ENGINEERING BULLETIN	Bulletin #: EB-01-16 <small>(Form Rev. 1)</small>
	Title: Design Change to the Disc and Seal for the External Chemical Hydraulic Valve	Date: Nov. 2016

Description of Bulletin: This bulletin provides details concerning a design change to the disc for the external chemical hydraulic valves (CH46955SST, CH46949SST, et. al.). It also provides instructions concerning rebuilds and seal kits.

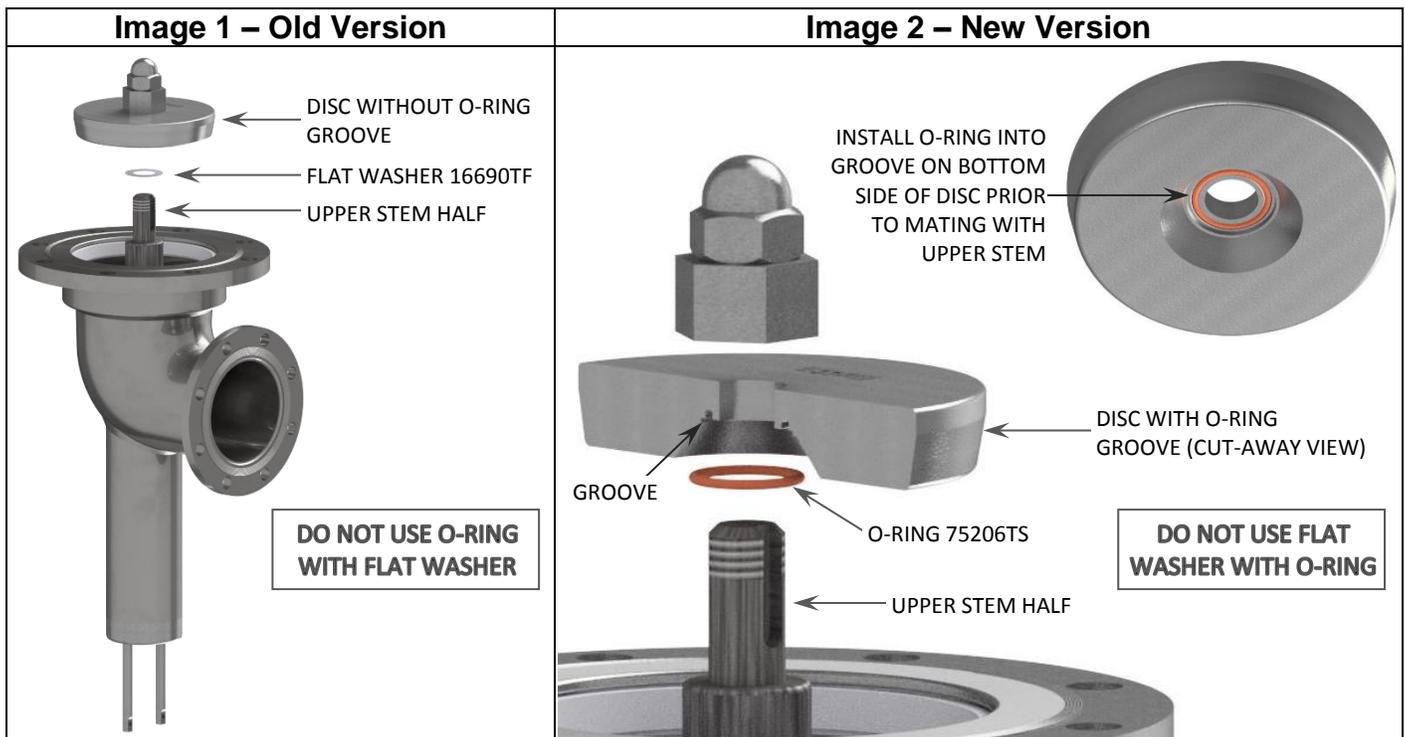
Background/Details: Valves produced prior to February 1, 2016 utilized a flat PTFE washer (16690TF) to seal the joint between the disc and upper stem half. (See image 1.) A design change has replaced the flat seal washer with a Tef-Sil O-ring (75206TS) installed in a machined groove in the disc. (See image 2.) This change was implemented to create a more effective seal and allow for metal-to-metal contact between the disc and the upper stem half. The metal-to-metal contact allows for consistent and continual tension on the stem shaft to keep the cap nut securely in place.

Bulletin Instructions: 75206TS O-ring is also used as the seal between the piston and piston holder. Rebuild kits will now include a second Tef-Sil O-ring (75206TS) to be used for the joint between the disc and upper stem, as highlighted above. Follow these guidelines for rebuild:

- If the disc has the O-ring groove, use the O-ring and discard the flat washer.
- If the disc does not have the O-ring groove, continue to use the flat washer and discard the extra O-ring.
